Technical Bulletin

October 3, 1997
Chilliwack, British Columbia

Attention: Elite customers and Rebel customers with split Flap/Aileron Retro kits only.
Subject: Flap-3 and Flap-9

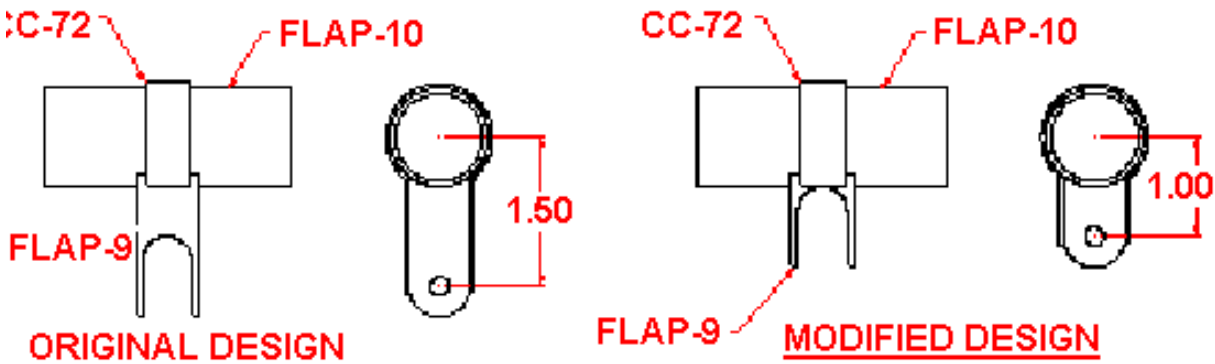
Flap-9 Horn and Flap-3 Aileron-Flap Horn Assembly have been modified as per the figures shown below. We believe that everyone affected is aware of the change and has received modified parts or are making the required changes themselves. The centre to centre distance has been reduced from 1 1/2" to 1". This change was made to reduce the amount of droop in the ailerons when the flaps were applied. This improves aileron response at full flaps.
